UNITED STATES PATENT AND TRADEMARK OFFICE

APPLICATION NO.	FILING DATE	FIRST NAMED INVENTOR	ATTORNEY DOCKET NO.	CONFIRMATION NO.
10/629,704	07/30/2003	Koji Arihara	051841-0109	5354
22428	7590	03/06/2006	EXAMINER	
FOLEY AND LARDNER LLP			KRAUSE, JUSTIN MITCHELL	
SUITE 500			ART UNIT	PAPER NUMBER
3000 K STREET NW			3682	
WASHINGTON, DC 20007			DATE MAILED: 03/06/2006

DETAILED ACTION

FIG. 19

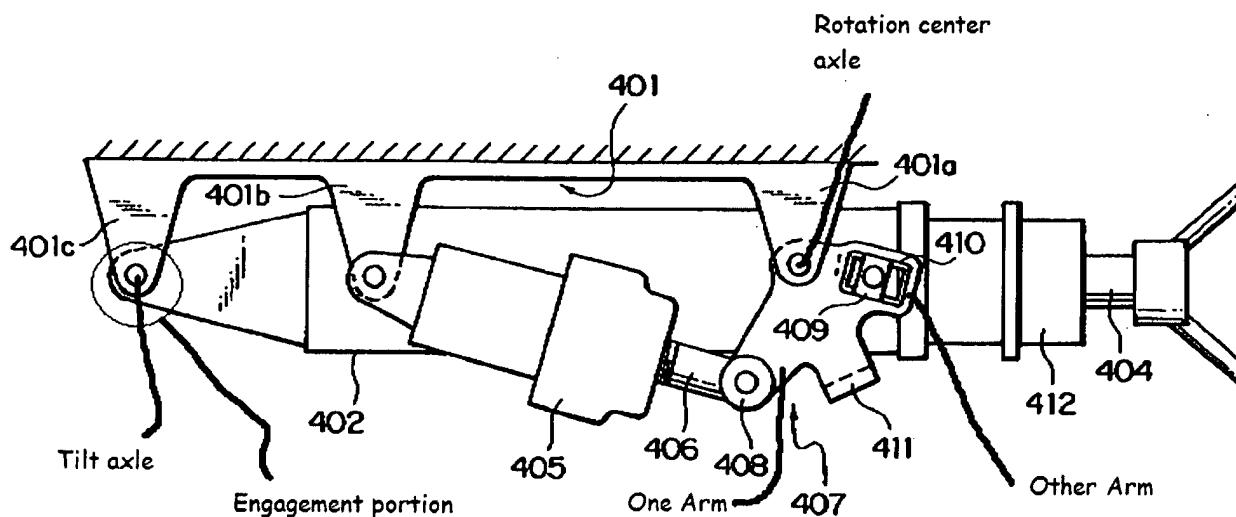
3. Claim 1 is rejected under 35 U.S.C. 102(e) as being anticipated by Tomaru (US 2002/0124677).

Tomaru discloses tilt adjustable steering column assembly for an automotive vehicle, comprising:

an elongated jacket tubular member (Fig 19; 402) having a tilt rotation axle (end near 401c) at one end thereof;

a fixed bracket (401a) placed at a predetermined middle position of the jacket tubular member and having an engagement portion that is engaged with a tilt input axle mounted on the jacket tubular member;

a bell crank lever (407) having a rotation center axle rotatably supported on the fixed bracket and rotatably supports the tilt input axle of the jacket tubular member on one arm thereof;

and an actuator (405 with 406) having a rod portion to operatively actuate another arm of the bell crank lever to be moved to pivot the bell crank lever, the fixed bracket supporting the rotation center axle of the bell crank lever to enable the rotation center axle of the bell crank lever to swing with respect to the fixed bracket and the engagement portion of the fixed bracket being formed in an elongated hole (410), the elongated hole being formed to coincide with a pivotal orbit of the tilt input axle about the tilt rotation center of the jacket tubular member.

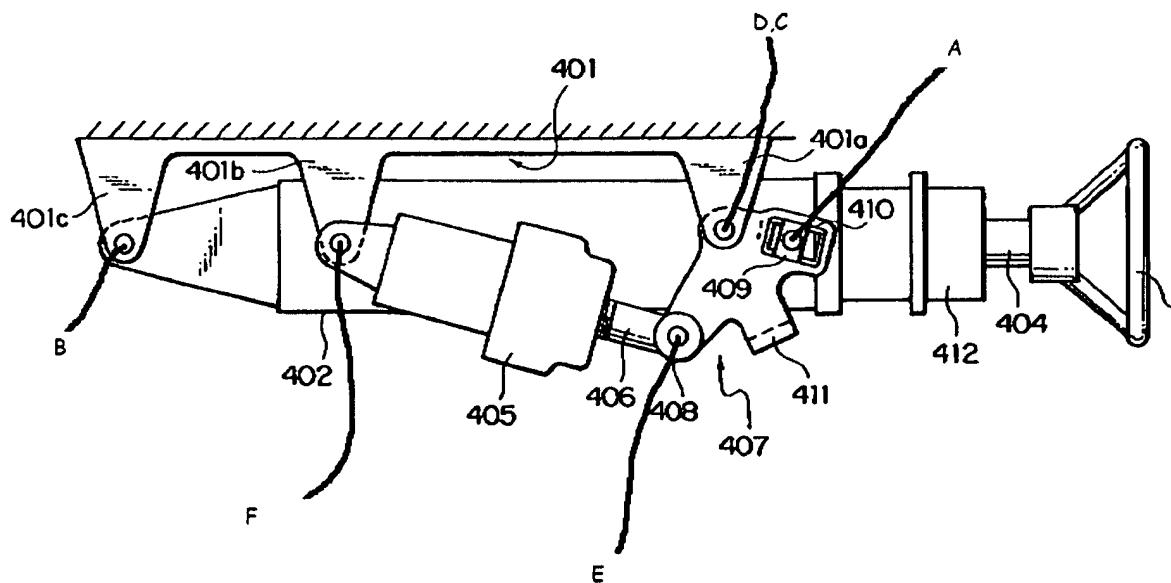
Regarding claim 10, the turning pair points are indicated in the drawing below using the same reference numerals (A-F) corresponding to the first through sixth turning pair points as described in claim 10. Points D and C appear to be directed to the same point, however are different due to the movement of the eccentric, which is not illustrated due to the fact that it is an incorporated teaching of Minamoto.
